**MAJOR PROJECT ASSESSEMENT:
University of Technology Sydney
Peter Johnson Building -
Redevelopment for student housing
Major Project Application MP 09_0021**

Director-General's
Environmental Assessment Report
Section 75I of the *Environmental Planning and
Assessment Act, 1979*

December 2009

Figure 6. Building elevations from Harris Street, and heights

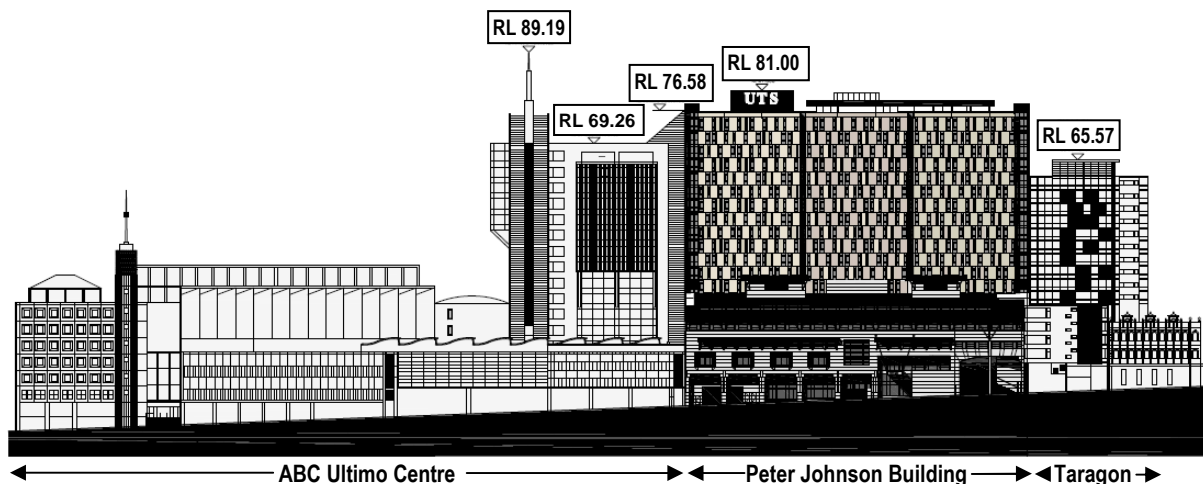
Concerns were raised in the public submissions about height, bulk and scale of the proposed development.

The highest part of the structure is RL 81.00. The top of the building would be 4.42m higher than the adjoining ABC building (excluding the spire), although the ground to roof height would be similar due to the change in ground levels along Harris Street. The proposal would also be 15.43m higher than the adjoining Taragon Building. The tower element is well set back from Harris Street and Broadway which will reduce the appearance of height, bulk and scale from these streets. The proposed height is also similar to the height of the building approved under the Council issued Development Consent for the site.

It is also noted that the development will be 52m lower than the existing 32 storey UTS tower building on the opposite side of Harris Street, and 53m less than the Concept Plan approved height of the Frasers/CUB Building 2 located further south on Broadway.

FSR of 7:1 in the Council issued Development Consent for the site. As stated above, the height, bulk and scale of the proposal does not result in adverse impacts on amenity or public domain and is not out of character with the surrounding scale of development along Harris Street. Accordingly, the additional FSR is supported.

The increased articulation and choice of materials of the revised design assists in reducing the appearance of bulk. The proposal is not out of scale or character with surrounding development in Harris Street or adjoining the UPN, and there are no significant amenity impacts as a result of the development.

Figure 8. Construction work zones.

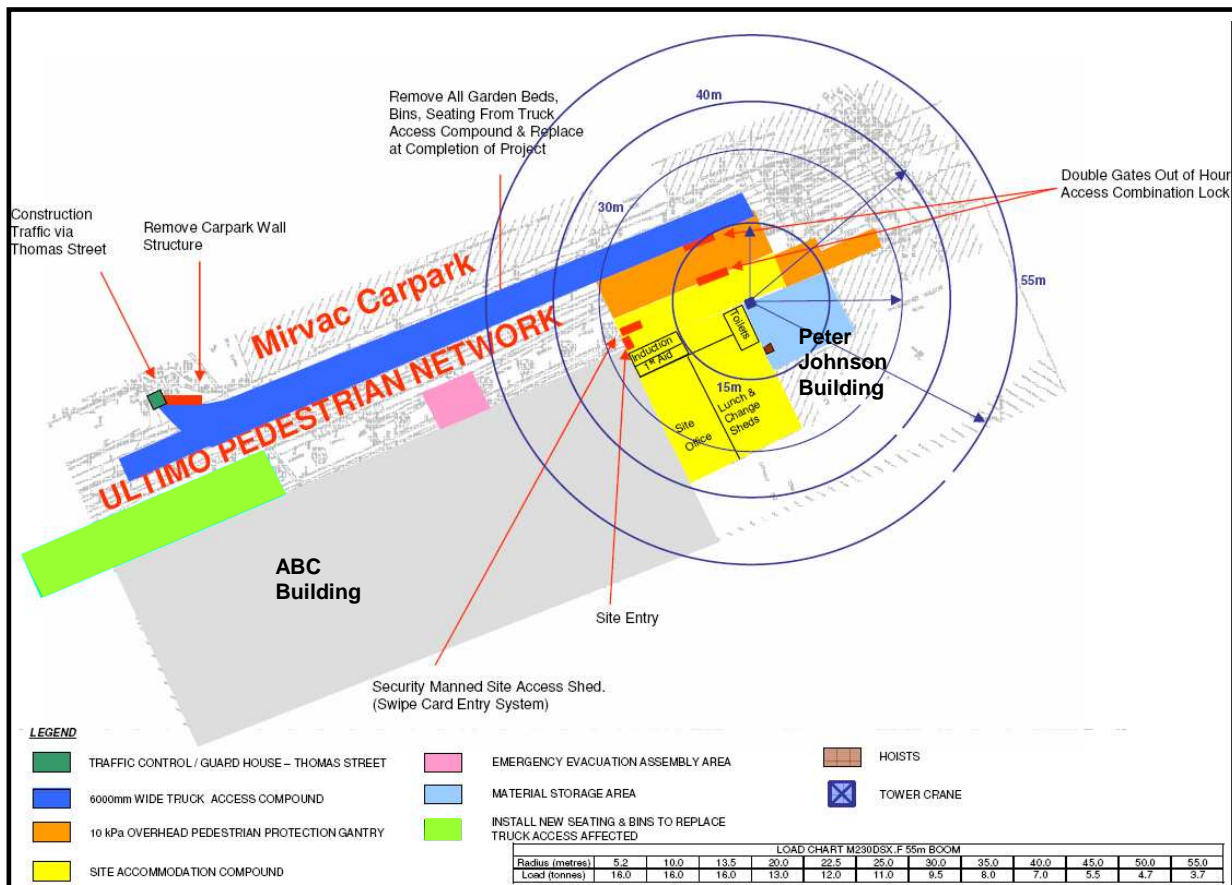
A detailed construction management plan is included in Appendix S of the EA. A works zone will be located in the UPN, accessed from Thomas Street. The access path will require the removal of the wall at the end of Thomas Street adjacent to the car park wall owned by Mirvac. The construction zone will include a 6m wide access area along the eastern side of the UPN, and covered hoardings to allow pedestrian access to be available to access the Devonshire Street Tunnel (refer to figure 8).

The CMP report identifies a number of areas requiring dilapidation reports prior to commencement of construction including the Mirvac car park and adjoining building. A condition of approval has been included to ensure the reports include the ABC building and Council property, and that upon completion of construction the paving, street furniture, trees in UPN affected by work zone should be replaced.

Figure 9: Pedestrian path of travel from Devonshire Street tunnel to Harris Street bridge

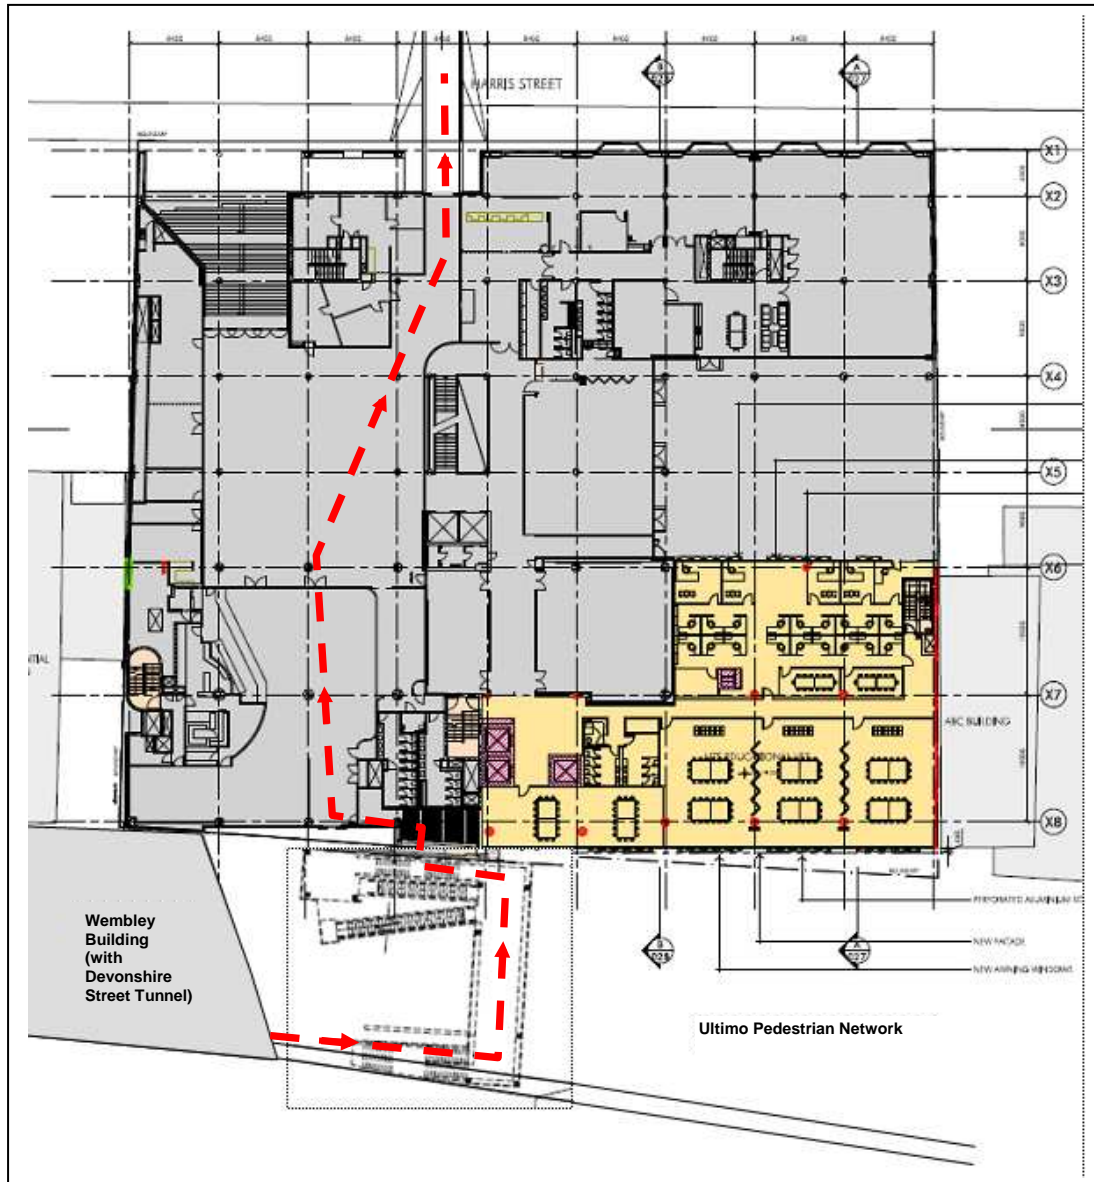
The elevated bridge and stairs over the UPN provides public pedestrian access from the Devonshire Street tunnel (from Central Station) to Level 4 of the Peter Johnson building. Level 4 is the main floor and foyer area within this building, and is connected to the ground floor of Building 1 on the campus by the Harris Street pedestrian bridge.

The City was of the opinion that the redevelopment creates an opportunity to remove the bridge, which is considered to be of poor visual quality.

UTS maintains that the UPN bridge and stair/escalator provides a publicly accessible path within the university with direct connection to public transport and should be retained. Public access from the UPN to Level 4 could be internalised (where it is only proposed for student housing residents) although modifications to the internal design of the building would be required. The Department considers that the issue will be best addressed as part of the UTS Broadway Concept Plan, which covers public domain improvements and pedestrian paths of travel across the site.
